April 16, 2015  
10 CFR 50.90  
L-2015-065

Turkey Point Units 3 and 4  
Docket Nos. 50-250 and 50-251  
Renewed Facility Operating License Nos. DPR-31 and DPR-41

Subject: License Amendment Request No. 237, Application to Revise  
Technical Specification Figure 3.1-2, Boric Acid Tank Minimum Volume

Figure 3.1-2  
BORIC ACID TANK MINIMUM VOLUME (1)  
Modes 1, 2, 3 and 4

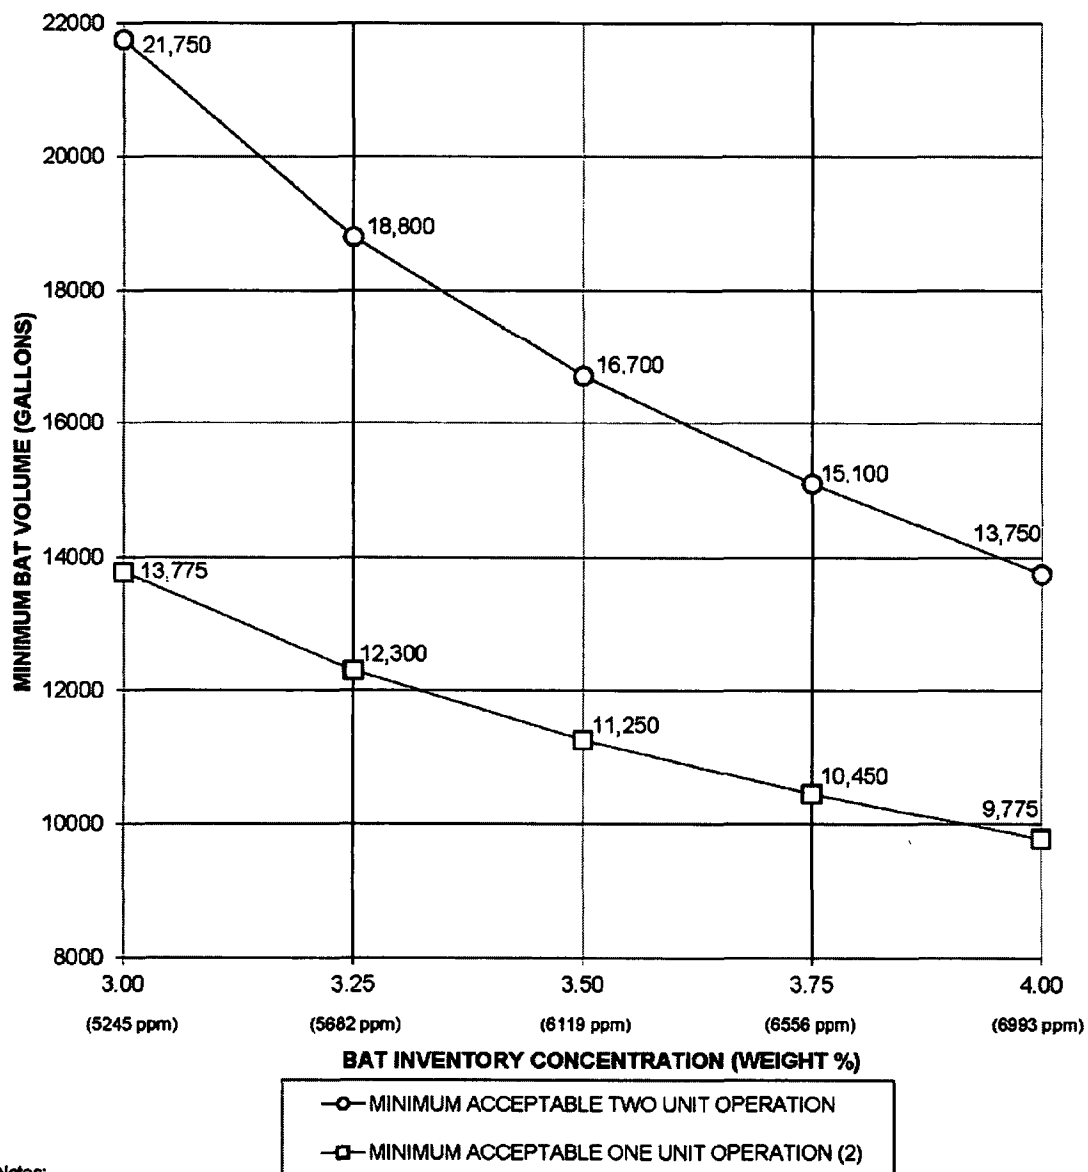
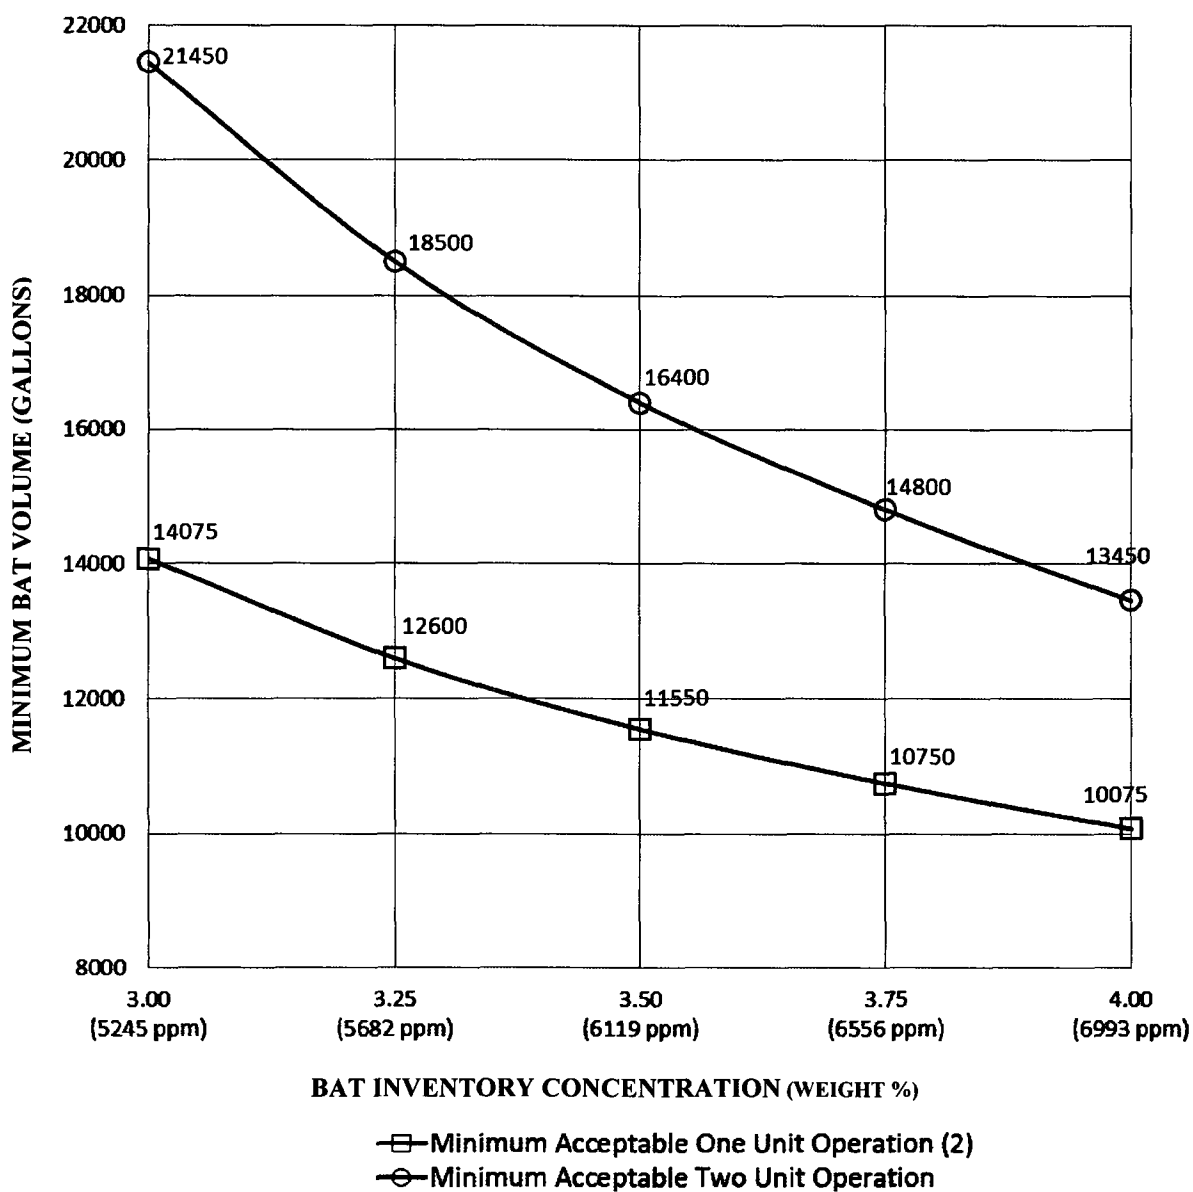
FPL proposes to revise TS Figure 3.1-2 to reflect a correction to the instrument uncertainty calculation. There are no proposed changes to TS 3.1.2.5 Limiting Condition for Operation (LCO) item a.

The current TS Figure 3.1-2 BAT minimum volume curve for two unit operation reflects a 1200 gallons uncertainty. The instrument uncertainty of 600 gallons described above was erroneously doubled to 1200 gallons and included in the BAT minimum volume curve for two unit operation. The BATs are common equipment that serves both units. Consequently, the instrument uncertainty for two unit operation should not have been counted twice when establishing the minimum acceptable BAT volume curve.

Additionally, an error was identified in the calculation of BAT volume measurement uncertainty used to establish the minimum acceptable BAT volume for the current TS Figure 3.1-2. The total loop uncertainty (TLU) for the BAT instrumentation that monitors BAT level is calculated using the square-root-sum-of-the-squares (SRSS). There are three BAT instrument loops that monitor BAT level; one for each tank. As described above, the three BATs are cross-tied together effectively creating one common tank for both Units 3 and 4. However, the conversion of the TLU into equivalent tank volume uncertainty (in gallons) was erroneously calculated based on the volume of a single BAT. The calculation should have considered the volume of the common tank for both units comprised of three BATs cross-tied together. As a result, the calculated TLU (in gallons) was underestimated. This error resulted in the instrumentation uncertainty increasing from 600 gallons to 900 gallons. This increase in the instrumentation's uncertainty value requires changes to the minimum acceptable BAT volume for a given boron concentration, for one unit and two unit operation shown on TS Figure 3.1-2.

The current TS Figure 3.1-2 minimum acceptable BAT volume curve for one unit operation reflects a 600 gallons instrument uncertainty. FPL proposes to revise TS Figure 3.1-2 by increasing the minimum acceptable BAT volume curve for one unit operation by 300 gallons to

reflect the revised instrument uncertainty of 900 gallons. This error constitutes a potential non-conservative TS. Pursuant to Administrative Letter 98-10 (Reference 2), administrative controls have been established to assure that the minimum acceptable BAT volume for one unit operation is maintained within the corrected values until the proposed amendment is approved by the NRC and implemented. Review of Turkey Point Units 3 and 4 past operating history since implementation of the current TS Figure 3.1-2 indicates that the units have operated within the proposed minimum acceptable BAT volume curve for one unit operation.

As previously discussed, the current TS Figure 3.1-2 minimum acceptable BAT volume curve for two unit operation erroneously reflect a 1200 gallons uncertainty (a 600 gallons uncertainty doubled). To correct this, the minimum acceptable BAT volume curve for two unit operation has been reduced by 600 gallons. Due to the other error identified in the calculation of BAT volume uncertainty, the BAT volume measurement uncertainty for two unit operation needs to be further revised by 300 gallons, making the final revised uncertainty 900 gallons. Therefore, the minimum acceptable BAT volume curve for two unit operation needs to be reduced by a total of 300 gallons (from 1200 to 600 to 900 gallons). The current TS Figure 3.1-2 BAT minimum volume curve for two unit operation is more restrictive than the proposed corrected values.

Figure 3.1-2  
BORIC ACID TANK MINIMUM VOLUME (1)  
Modes 1, 2, 3 and 4

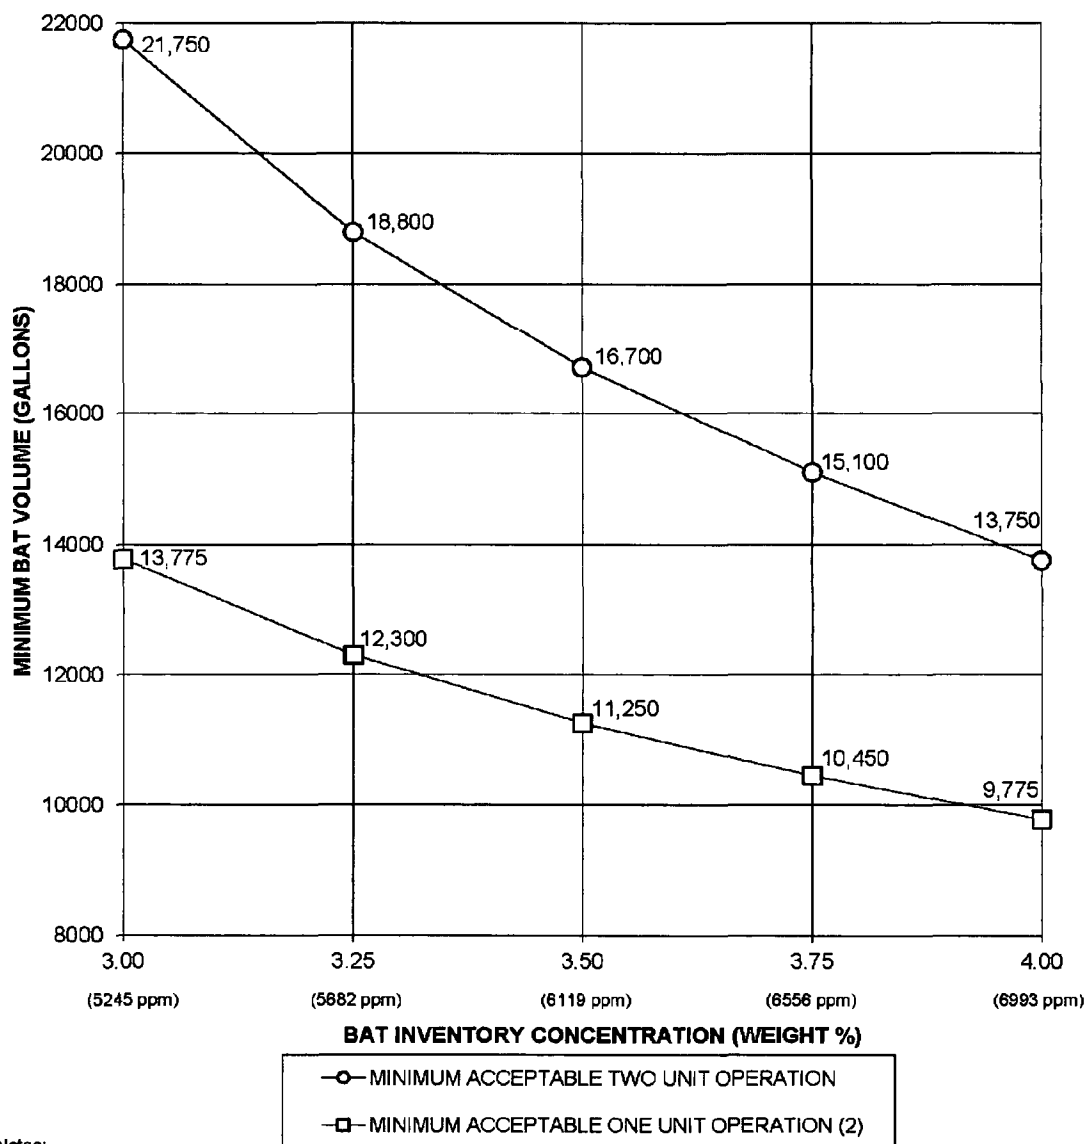
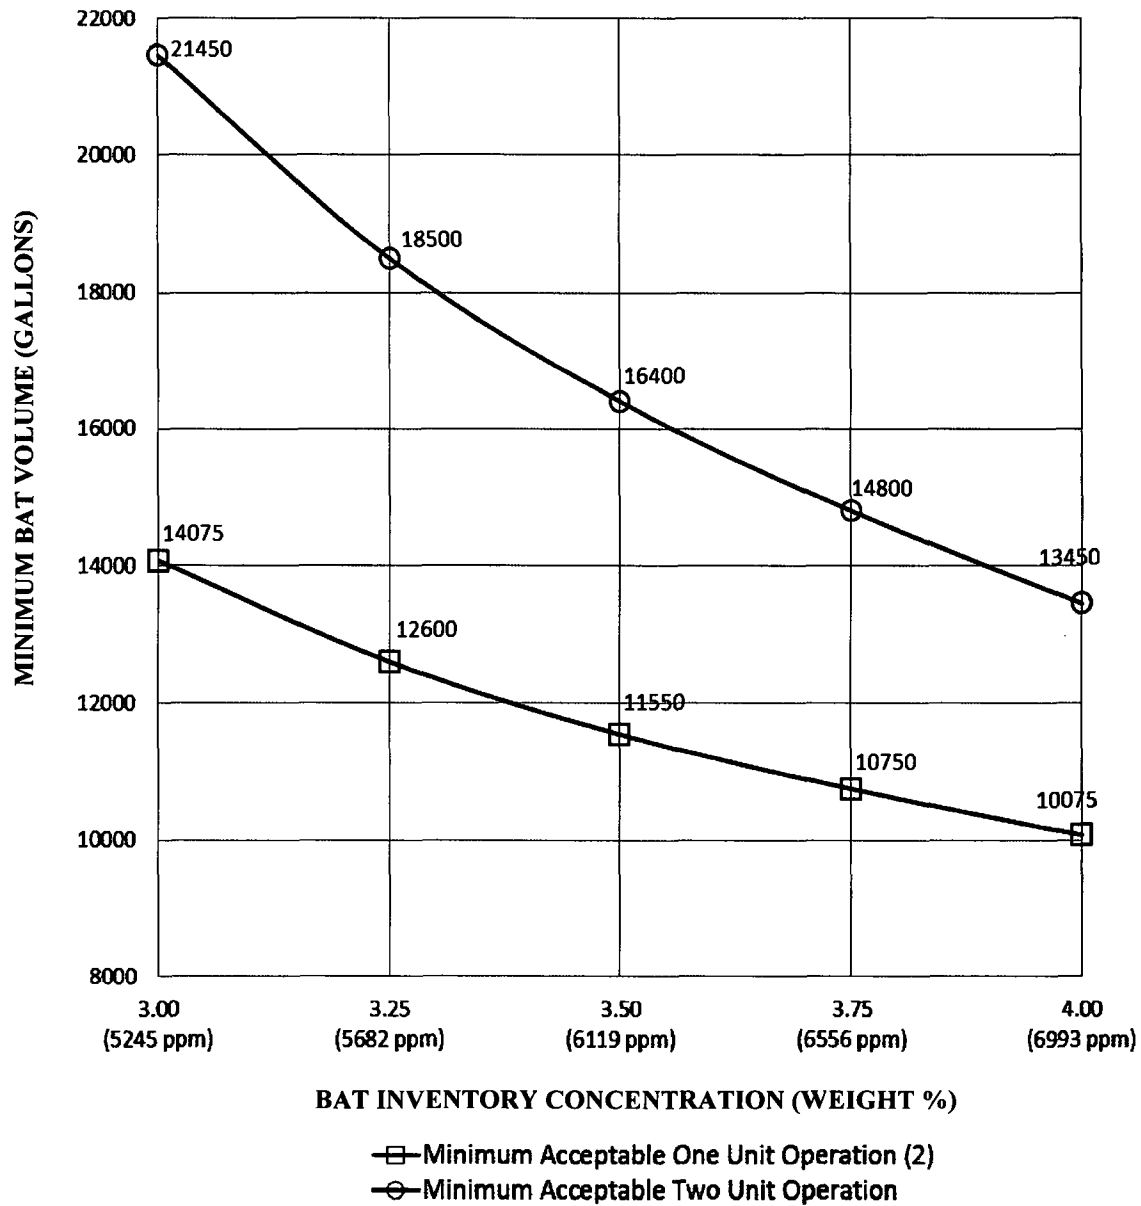
**Delete Figure 3.1-2 and  
Insert A**
